Sheet: /DDS Chip/
File: dds_ic.sch

Sheet: /MCU/
File: MCU.sch

Sheet: /USB/Power/
 File: USB.sch

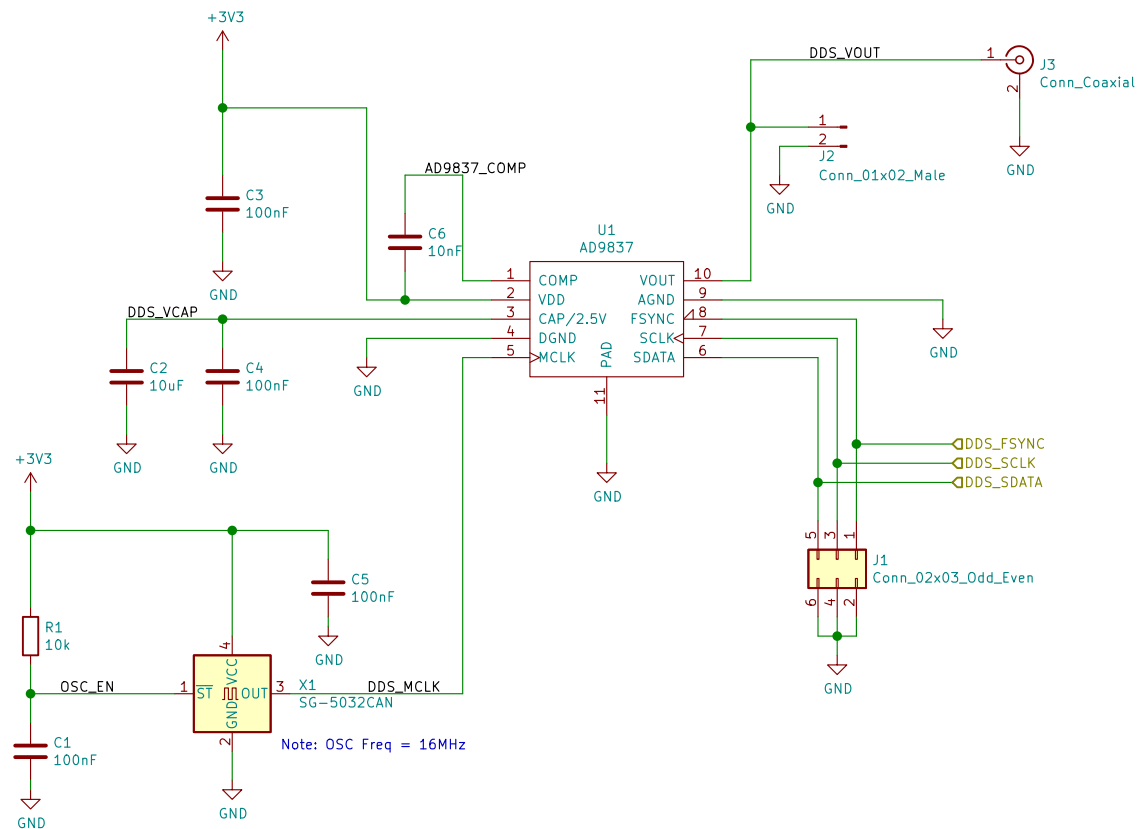
Should there be a separate LDO/power supply JUST for the AD9837?

Seems like reference design uses DVDD exclusively for OSC/digital cmpts, then has separate AVDD that supplies the AD9837.
